Well Name: MESQUITE 3 FED	Well Location: T18S / R31E / SEC 3 / NWSW / 32.7751323 / -103.8638428	County or Parish/State: EDDY / NM
Well Number: 2	Type of Well: OIL WELL	Allottee or Tribe Name:
Lease Number: NMNM89879	Unit or CA Name:	Unit or CA Number:
US Well Number: 300152540600S1	Operator: MATADOR PRODUCTION COMPANY

Notice of Intent

Type of Action: Plug and Abandonment

See Attached
for Revised Procedure

Mesquite 3 Federal #2
2130' FSL & 660' FEL Sec.3-T18S-R31E
Eddy County, NM
API: 30-015-25406
CURRENT WELLBORE SCHEMATIC
Spudded: 10/23/1985

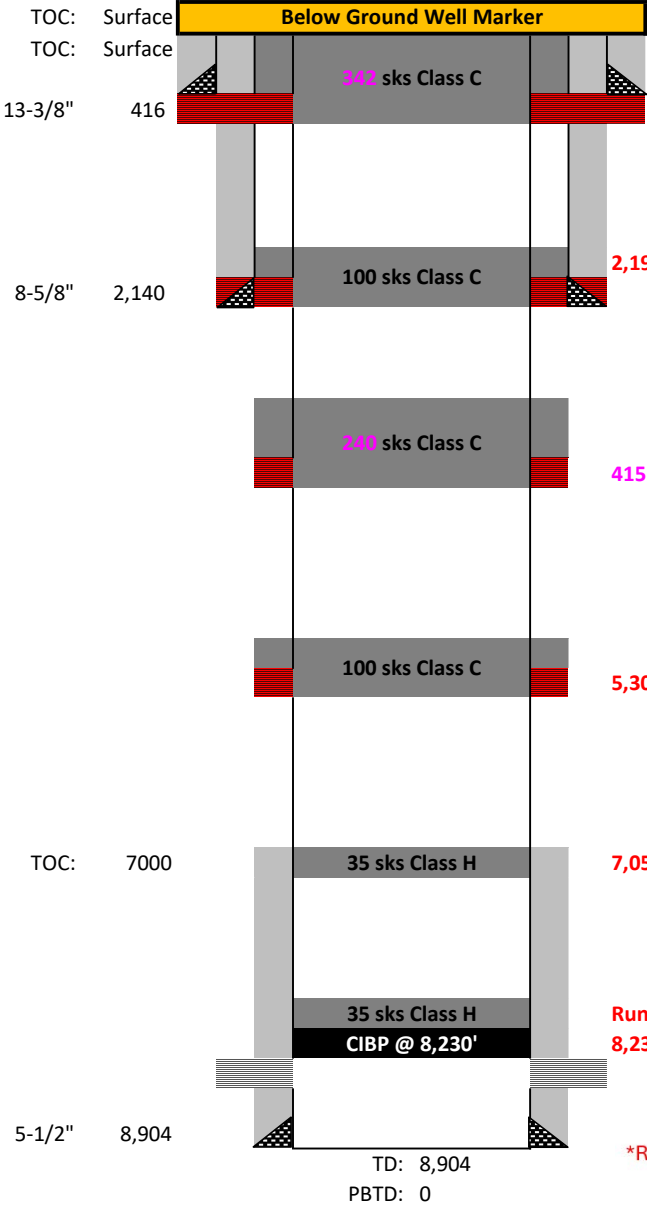
950': Perf and attempt to inject.
If NO injection, RIH to 1000' and spot 100 sxs (Depends on TOC) class C cmt to TOC or Surface (Rustler, Top of Salt, & Surface Shoe) WOC & Tag
If injection is established, circulate class C cmt to surface on all strings. (Est. 342 sks) (Rustler, Top of Salt, & Surface Shoe) WOC & Tag

2,190': Perf and attempt to inject.
If NO injection, RIH to 2,240' and spot 40 sks class C cmt (Req. 1,865') (Int. Shoe, Yates, & Base of Salt) WOC & Tag
If injection is established, squeeze 100 sks class C cmt (Req. 1,865') (Int. Shoe, Yates, & Base of Salt) WOC & Tag

4155': Perf and attempt to inject.
If NO injection, RIH to 4205' and spot 108 sks class C cmt (Req. 3,118') (Grayburg & Queen) WOC & Tag
If injection is established, squeeze 240 sks class C cmt (Req. 3,118') (Grayburg & Queen) WOC & Tag

5,308': Perf and attempt to inject.
If NO injection, RIH to 5,358 and spot 45 sks class C cmt (Req. 5,085') (Bone Springs) WOC & Tag
If injection is established, squeeze 100 sks class C cmt (Req. 5,085') (Bone Springs) WOC & Tag

7,050': Spot a 35 sks class H cmt balanced plug (Est. 6,766' / Req. 6,950') (TOC) WOC & Tag

Run RCBL From 7,946' To Surface, Report findings to BLM
8,230': Set CIBP; Circulate wellbore full of MLF; Pressure Test casing to 500psi for 30 minutes & Bubble Test; Spot 35 sks class H cmt (Open Bone Springs Perfs) (Est. 7,946') WOC & Tag.
12/3/1985: Bone Springs Perfs (8,280'-8,387')

*Run CBL from CIBP to surface.

Submit results to BLM.
